**BROWNS FERRY NUCLEAR PLANT (BFN) - UNITS 1, 2, AND 3 -
TECHNICAL SPECIFICATIONS (TS) CHANGES TS-431 AND TS-418 -
EXTENDED POWER UPRATE (EPU) - RESPONSE TO ROUND 7 REQUESTS
FOR ADDITIONAL INFORMATION (TAC NOS. MC3812, MC3743, AND
MC3744)**

**TECHNICAL SPECIFICATIONS (TS) CHANGES TS-431 AND TS-418 -
EXTENDED POWER UPRATE (EPU) - RESPONSE TO ROUND 7 REQUESTS FOR
ADDITIONAL INFORMATION (TAC NOS. MC3812, MC3743, AND MC3744)**

This enclosure provides TVA's response to the NRC staff's July 19, 2006, Round 7 Requests for Additional Information (RAI) for BFN Unit 1 and BFN Units 2 and 3, respectively). In addition, this enclosure also provides responses to a supplemental Round 7 set of steam dryer questions provided by NRC staff email transmission on July 12, 2006. Where the same or similar information was requested for all BFN units, the responses to the Round 7 RAIs are combined below for all three BFN units. Unless specified otherwise, the responses provided are applicable to all three BFN units.

Figure EEMB.39-1
Typical Steam Separator

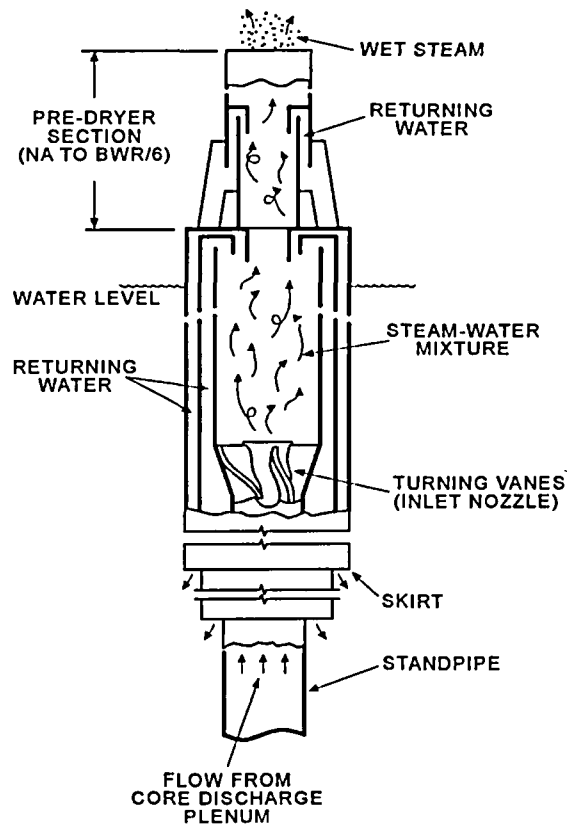
TVA Response to RAI EEMB.39 (Units 2 and 3)

Also, there are no known structural problems related to temperature or flow effects in steam separators. Thus, EPU is not expected to have any detrimental effect on the structural integrity and functionality of the steam separators.

Figure EEMB.C.15-1

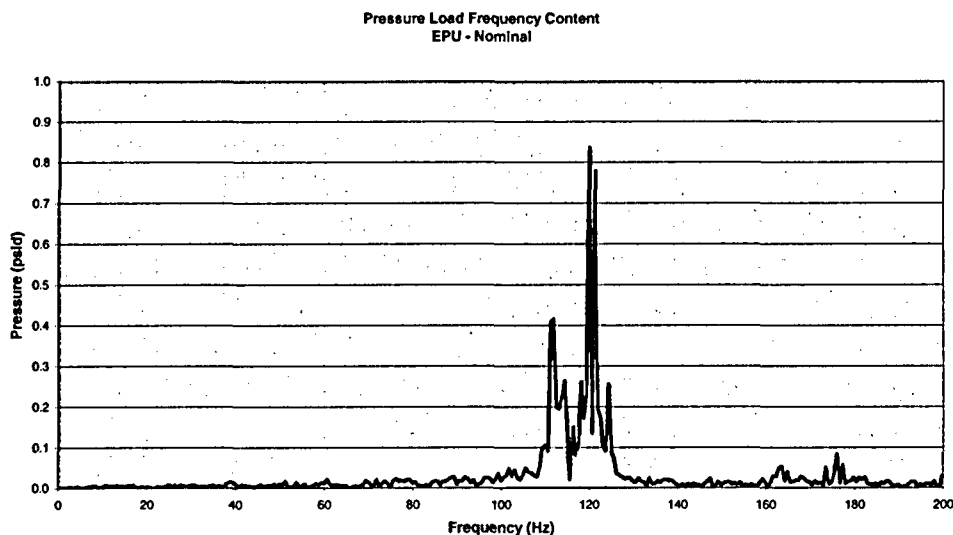
Discuss the source of the pressure peak near 175 Hz in Figure 6-1.

Review of the BFN main steam line geometries does not identify any MSL components that would contribute this frequency content. This review suggests that the frequency content near 175 Hz is not a deep cavity resonance similar to the ~120 Hz frequency content. Also, the 175 Hz content is similar to the lower frequency steam dome acoustic mode frequency content in two regards: 1) amplitude of resonance is much lower than S/RV resonance and closer to amplitude of lower frequency steam dome acoustic mode resonances, and 2) the frequency content is more broadband than an S/RV resonance and is more similar to the appearance of the steam dome acoustic resonances. Figure EEMB.C.15-1 below contains the same data as presented in Figure 6-1 of GE-NE-0000-0053-7413-R2-P; however, the axes are presented in linear scale rather than log scale. This more clearly shows that the amplitude of the 175 Hz frequency content is substantially lower than the S/RV resonance. The plots contained in Appendix D of GENE-0000-0052-3661-01 show the more broadband nature of this frequency content as measured in the SMT. GE testing has shown that the majority of the fluctuating load applied to the steam dryer is contributed by steam dome acoustic modes excited by various aero-acoustic sources in the BWR main steam system. The steam dome acoustic modes with pressure anti-nodes adjacent to the main steam nozzles are considered to be more susceptible to excitation than modes without anti-nodes close to the main steam nozzles because the majority of the main steam system sources exist in the main steam lines. It is considered probable that this load component is contributed by a steam dome acoustic mode as described above.
